ADDENDUM NO. 3

Subject: **Invitation to Tender No. FP802-170263**

Title: **Floating Dock Installation**

Location: **Fishing Harbour of Grande-Rivière – Gaspesia region, Qc**

Site photos.

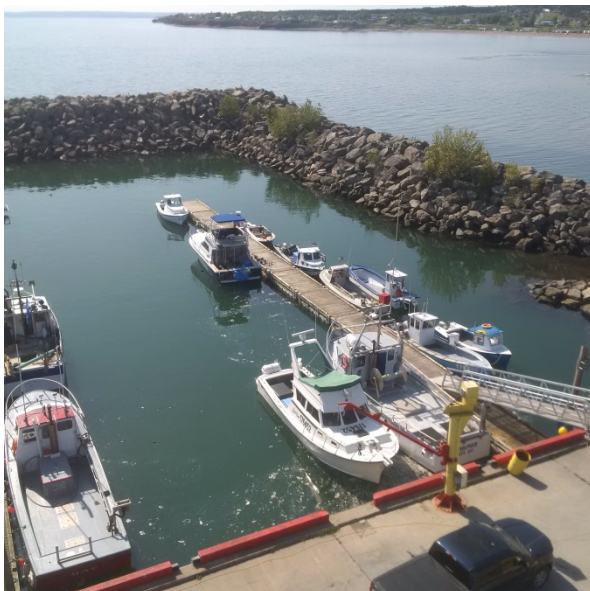
Is it possible to attach photographs of the work site

DFO Answer 10:
